Agenda Page 1

PLN21/0316 - 398-400 JOHNSTON STREET ABBOTSFORD - REFERRAL COMMENTS

Council Reference	PLN21/0316
То	Michelle King- Principal Planner, City of Yarra
From	kinetica

Development Engineering Formal Referral Response

Figure 3 - Recommended height and massing (source: MA Architects, with annotations added).

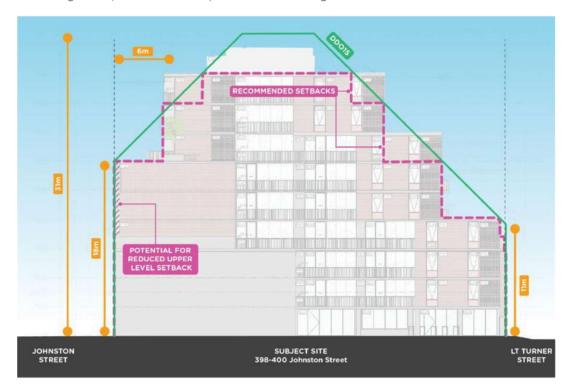
To reduce the buildings visual bulk and respond to the 45-degree setback plane as outlined in DDO15, we recommend the following setbacks be increased (this is also shown in Figure 3):

- · Levels 06 is set back an additional 6 metres (approx.) from the rear; and
- Levels 08 is set back an additional 3 metres (approx.) from the rear.

To ensure the massing better responds to the 45-degree setback plane outlined in DDO15, above Level 07, we recommend Level 08 is setback a further 3.0m (approx.) from the levels below. This change will both ensure the top level of the building reads as a cap to the building, while also minimising the impact of the development on vistas along Johnston Street.
